Seabrook Station

NextEra Energy Seabrook, LLC's First Six-Month Status Report in Response to March 12, 2012  
Commission Order Modifying Licenses with Regard to Reliable Spent Fuel Pool Instrumentation  
(Order Number EA-12-051)

**FIRST SIX MONTH STATUS REPORT FOR THE  
IMPLEMENTATION OF ORDER EA-12-051, ORDER MODIFYING  
LICENSES WITH REGARD TO RELIABLE SPENT FUEL POOL  
INSTRUMENTATION**

**SPENT FUEL POOL LEVELS  
ELEVATION VIEW**

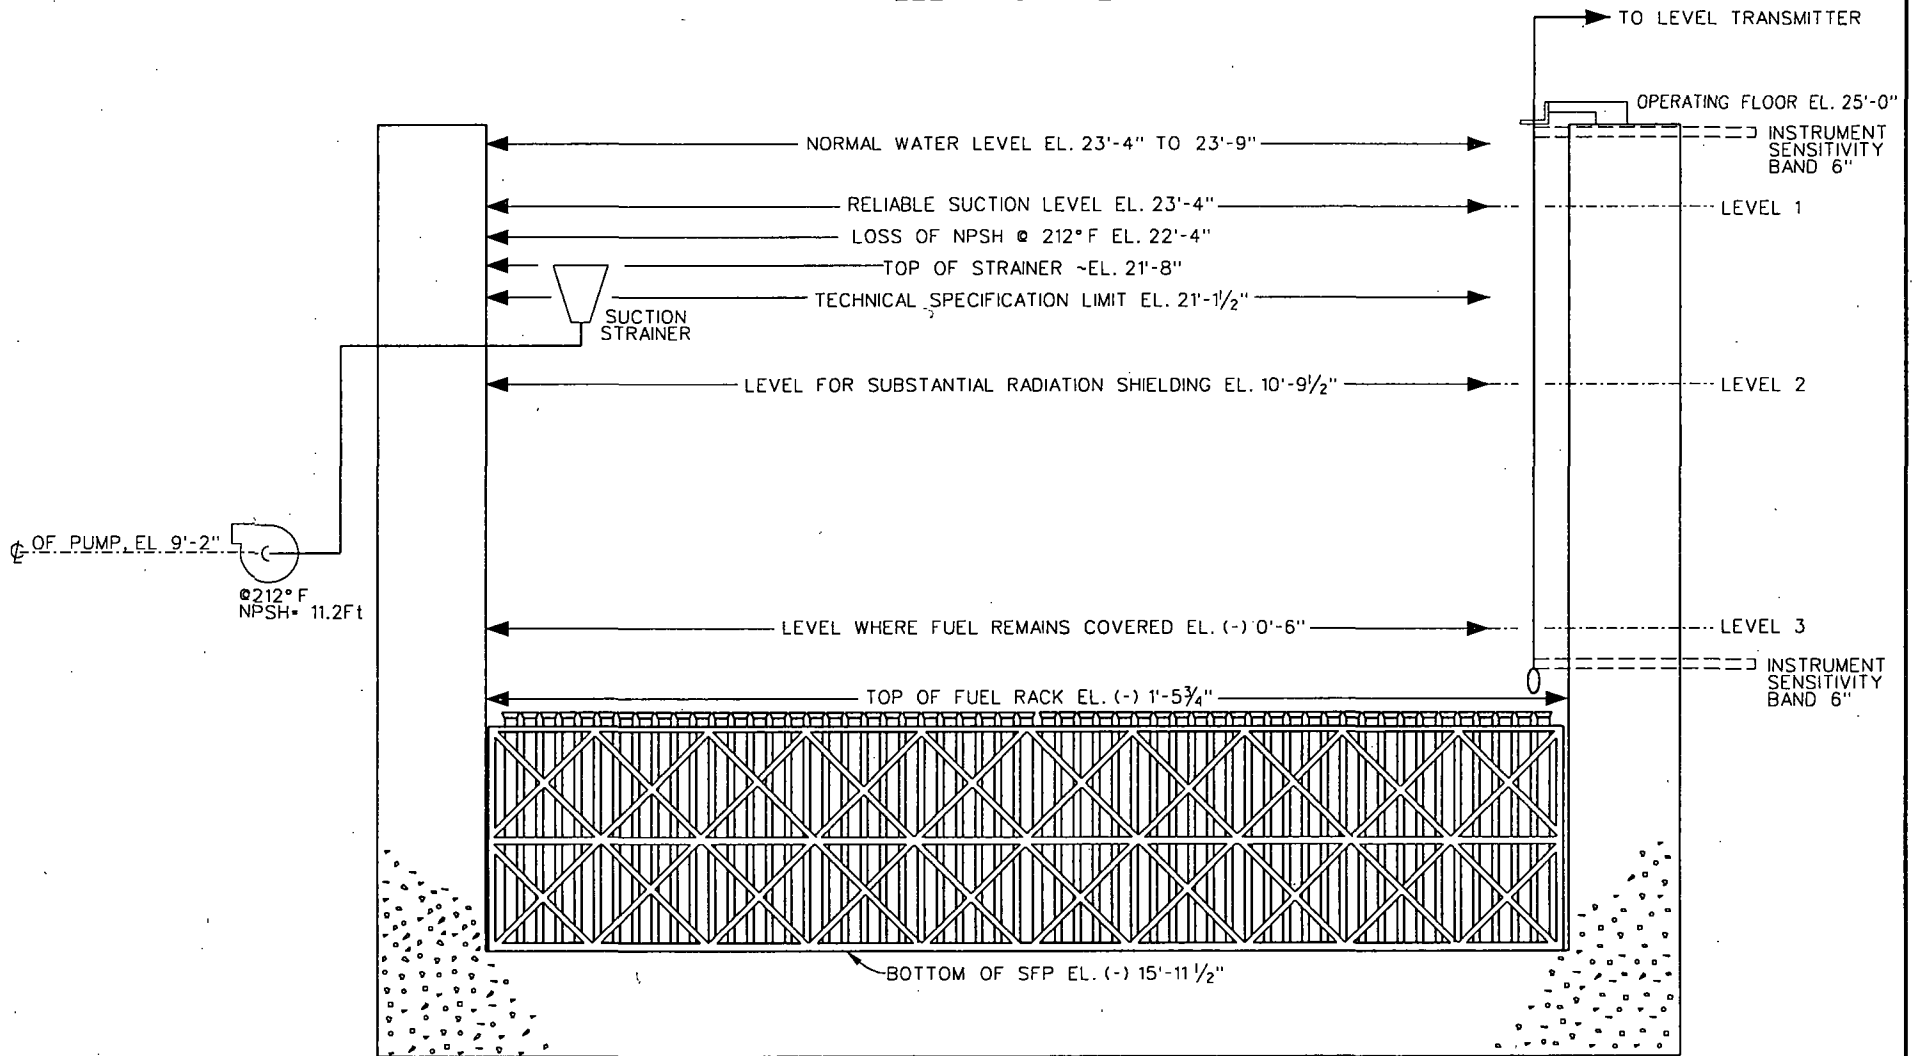
*b) A clearly labeled sketch depicting the elevation view of the proposed typical mounting arrangement for the portions of instrument channel consisting of permanent measurement channel equipment (e.g., fixed level sensors and/or stilling wells, and mounting brackets). Indicate on this sketch the datum values representing Level 1, Level 2, and Level 3 as well as the top of the fuel racks. Indicate on this sketch the portion of the level sensor measurement range that is sensitive to measurement of the fuel pool level, with respect to the Level 1, Level 2, and Level 3 datum points.*

Enclosure 2 contains an elevation view of the proposed arrangement for the portions of the instrument channel consisting of permanent measurement channel equipment. In addition, the datum values for the Levels 1, 2 and 3 are depicted as well as the assumed sensitivity and accuracy of the equipment.

**PLAN VIEWS OF INSTRUMENT  
CHANNEL ARRANGEMENT**

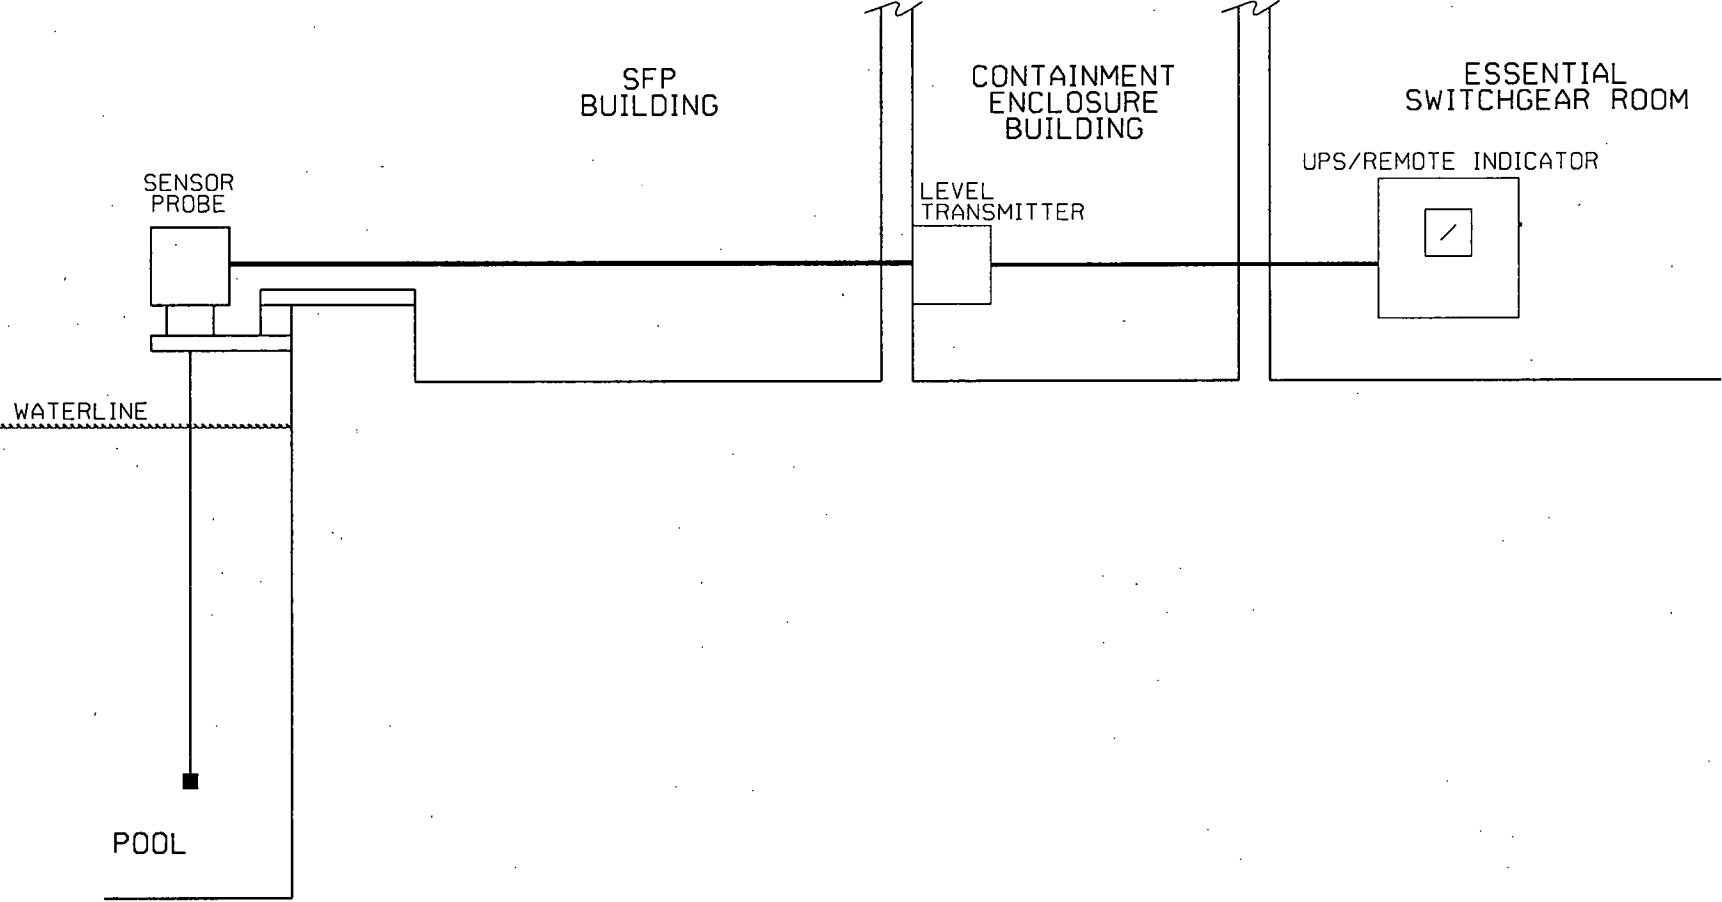
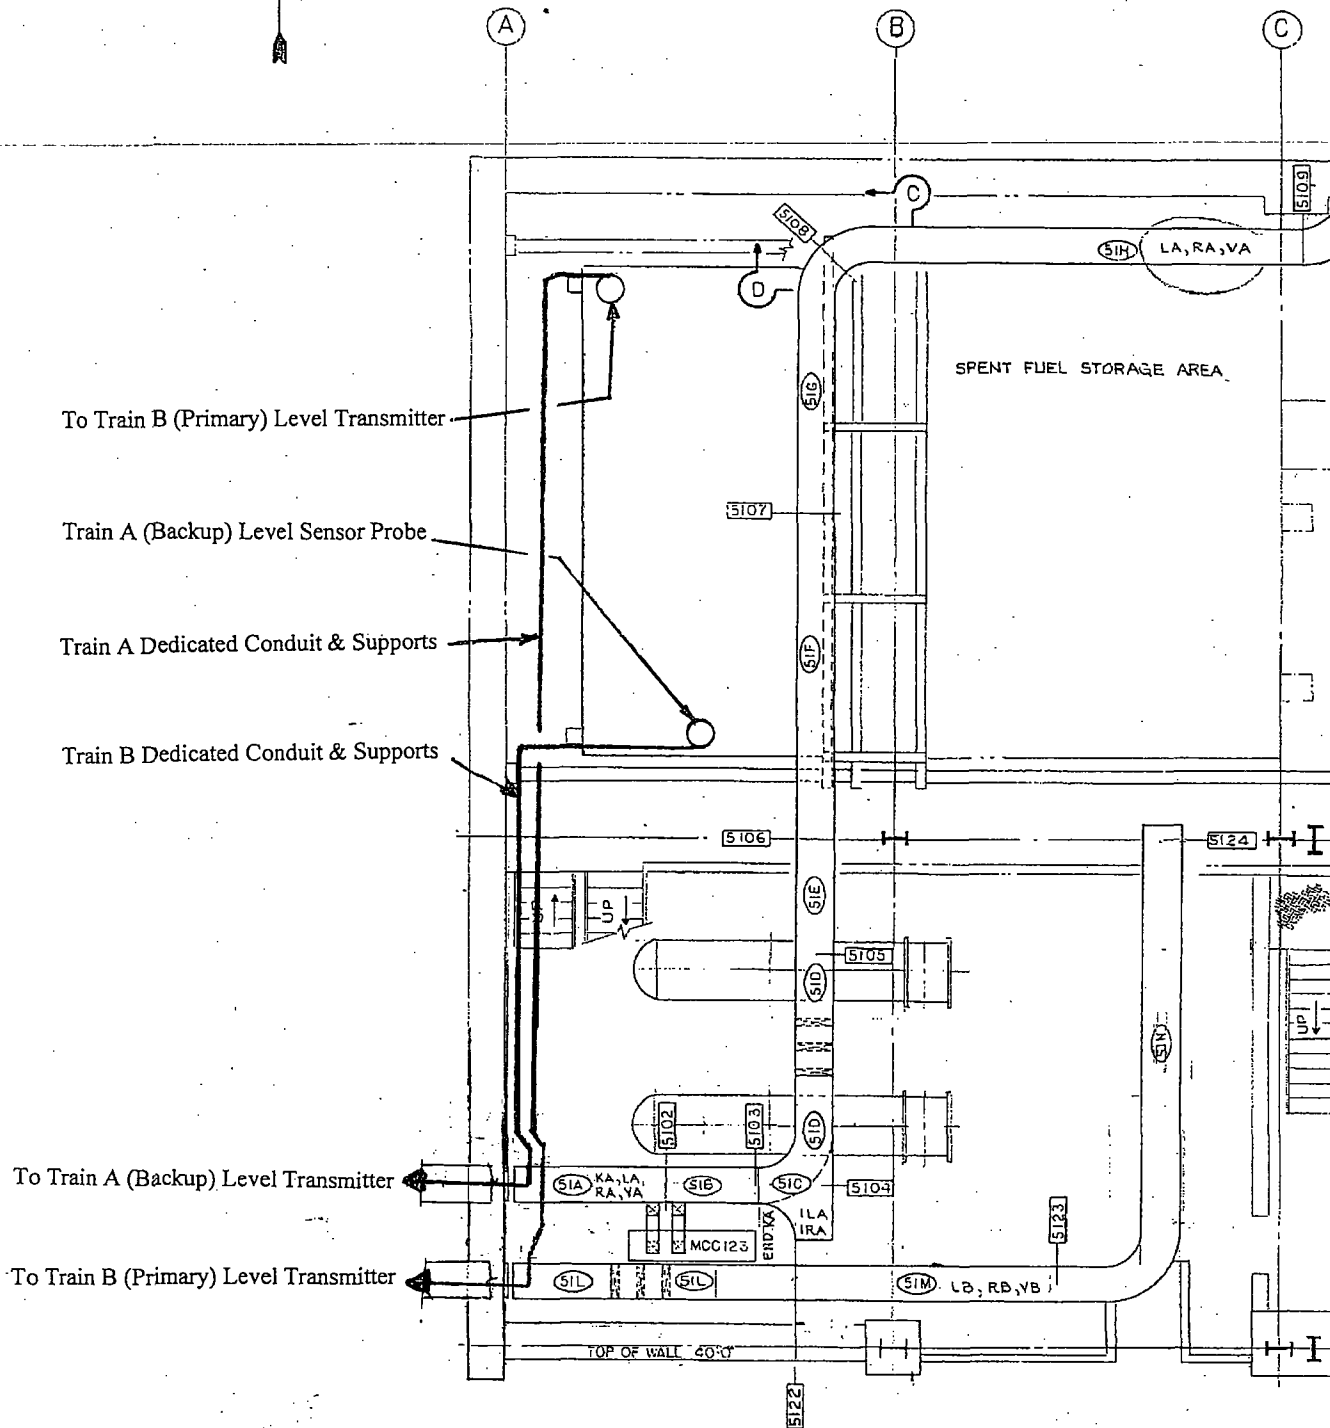
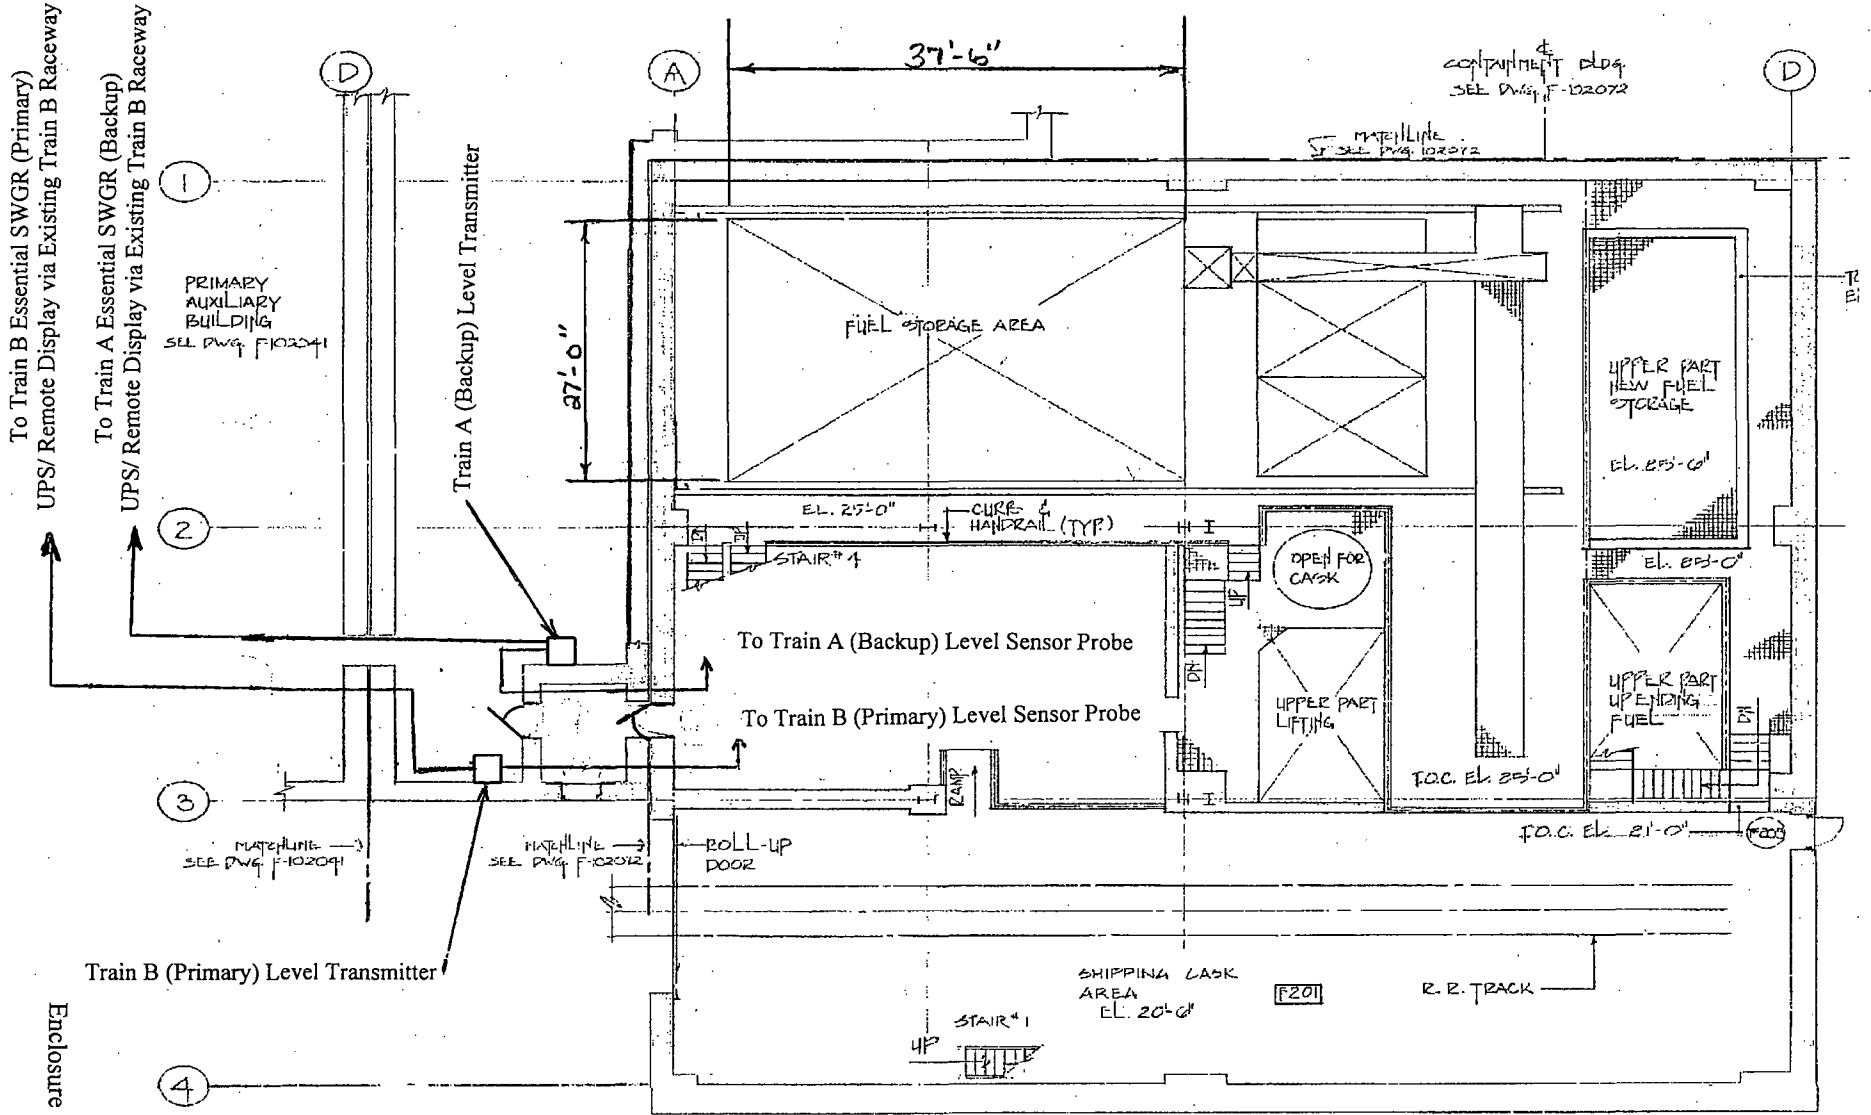
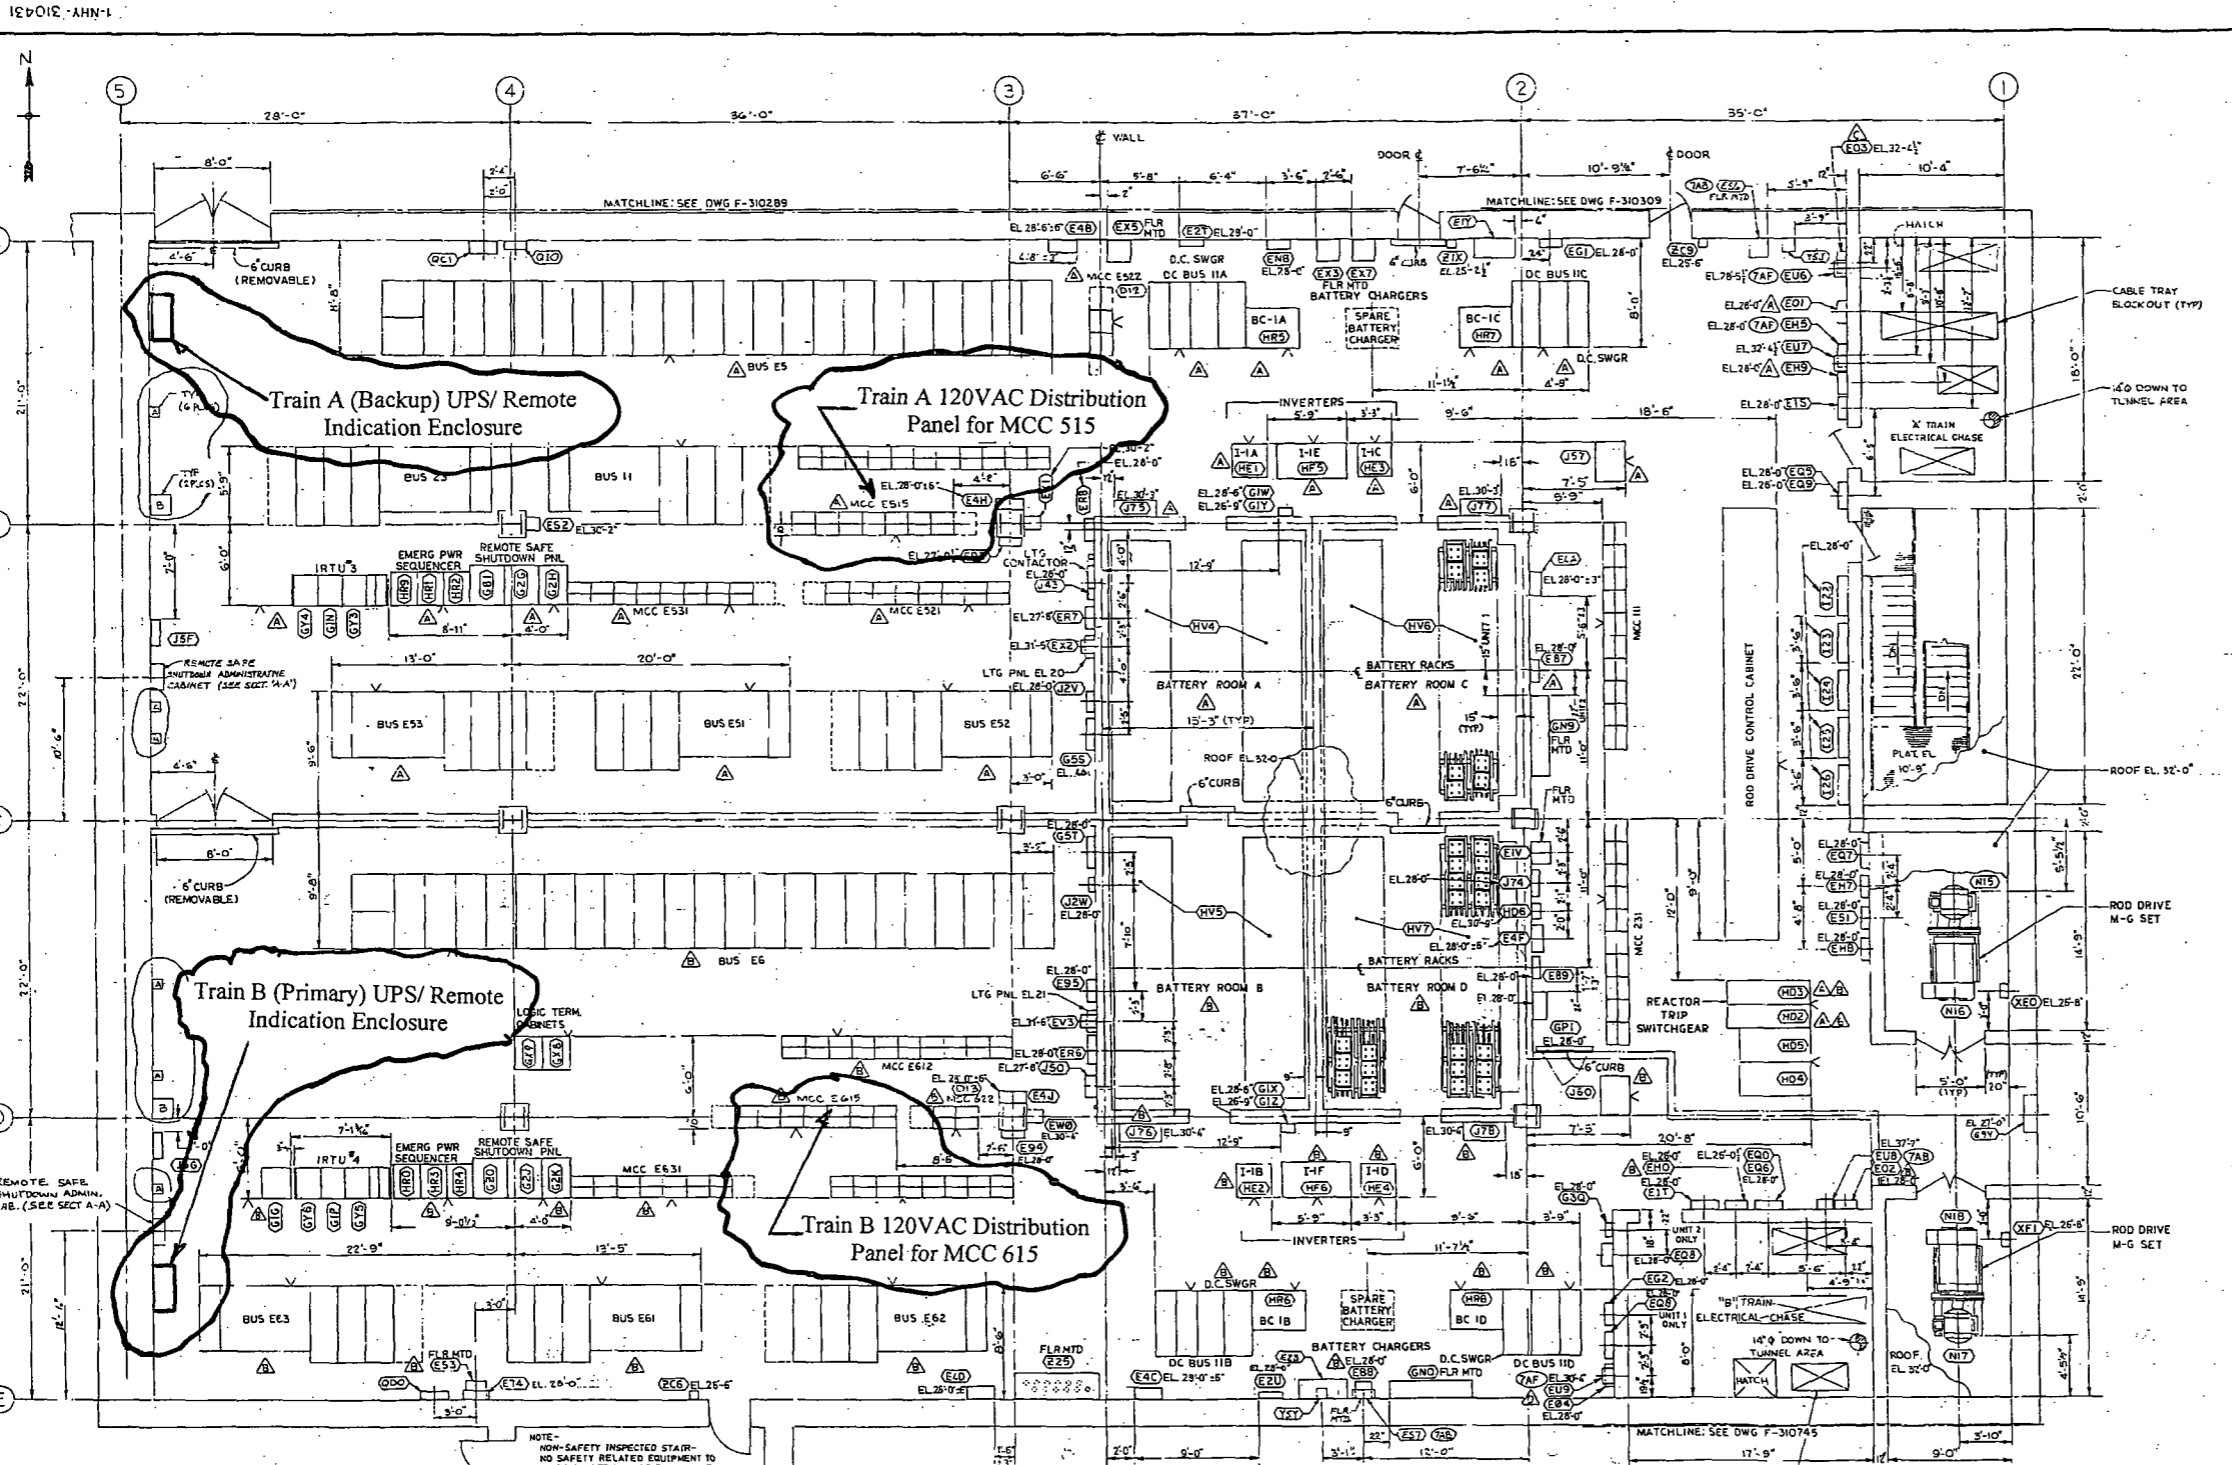
*Please modify the sketch in Figure 1 or provide a marked-up plant drawing of the plan view of the SFP area, depicting the SFP inside dimensions, the planned locations/placement of the primary and back-up SFP level sensors, and the proposed routing of the cables that will extend from the sensors toward the location of the local electronics cabinets and read-out/display devices in the main control room or alternate accessible location.*

Enclosure 3 contains a plan view of the proposed arrangement for the portions of the instrument channel consisting of permanent measurement channel equipment. As requested the enclosure depicts the inside dimensions of the SFP, planned placement of the primary and backup level sensors in the SFP and the proposed routing of cables that will connect the sensors to the level transmitters. The location of the signal conditioning processor module (level Transmitter) for each channel has been revised from the Primary Auxiliary Building to the Containment Enclosure Building. The planned location of the UPS/ remote display in the Train A and Train B Essential switchgear Rooms is also provided.
